Access Compliance Report

Public Rights-of-Way

(Curb Ramps)

Intersection ID: 17403	Main Street: CHADSFORD_PL	Cross Street: VERNON_DR	Location: E
ADA ID: DCDEB2258081	Ramp Type: PerpDiag	Initial Pass/Fail: Fail	Overall Compliance: No
Codes/Mitigation Info/Possible Solution		Field Measurements/Component Compliance	
Severity Score: 33.75

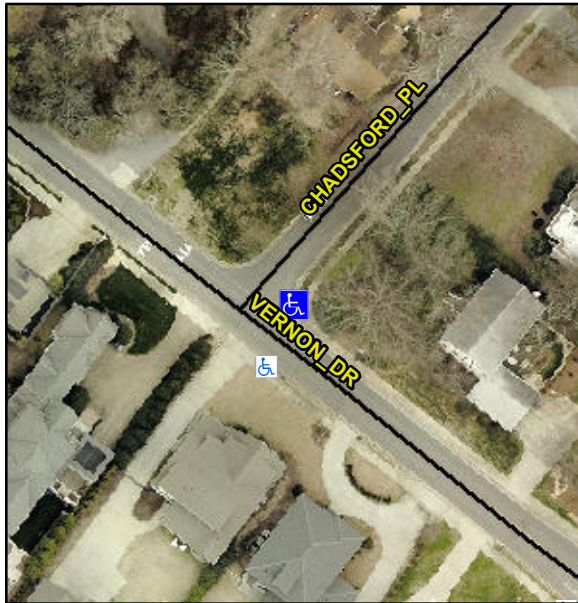
Possible Solutions:

Remove & Replace Curb Ramp With Two New Directional Ramps or Equivalent.

PROW/ADA:

R304.5.1, R304.2.2

Compliance	Description	Data	Compliance	Description	Data
N/A	Ramp Length (in)	52.0	No	Ramp Slope (%)	12.2
No	Ramp Width (in)	45.5	Yes	Ramp XSlope (%)	0.7
N/A	Flare Type LT	N/A	N/A	Flare Type RT	N/A
N/A	Flare Slope LT (%)	N/A	N/A	Flare Slope RT (%)	N/A
N/A	Flare Traversable LT?	N/A	N/A	Flare Traversable RT?	N/A
N/A	Landing Length (in)	N/A	N/A	DWS Provided?	N/A
N/A	Landing Width (in)	N/A	N/A	DWS Contrast?	N/A
N/A	Landing Slope (%)	N/A	N/A	DWS Length (in)	N/A
N/A	Landing X Slope (%)	N/A	N/A	DWS Full Width?	N/A
N/A	Landing Curb? (Y/N)	N/A	N/A	DWS Offset (in)	N/A
N/A	Shared Landing?	N/A			
N/A	Gutter Ponding?	N/A	N/A	Gutter Slope (%)	N/A
N/A	Gutter Lip Ht (in)	N/A	N/A	Gutter X Slope (%)	N/A
N/A	Painted X Walk1?	No	N/A	Painted X Walk2?	No
	X Walk 1 Direction	To NW		X Walk 2 Direction	To SW
N/A	X Walk 1 Width (in)	N/A	N/A	X Walk 2 Width (in)	N/A
	X Walk 1 Slope (%)	2.7		X Walk 2 Slope (%)	2.7
	X Walk 1 X Slope (%)	2.9		X Walk 2 X Slope (%)	2.8
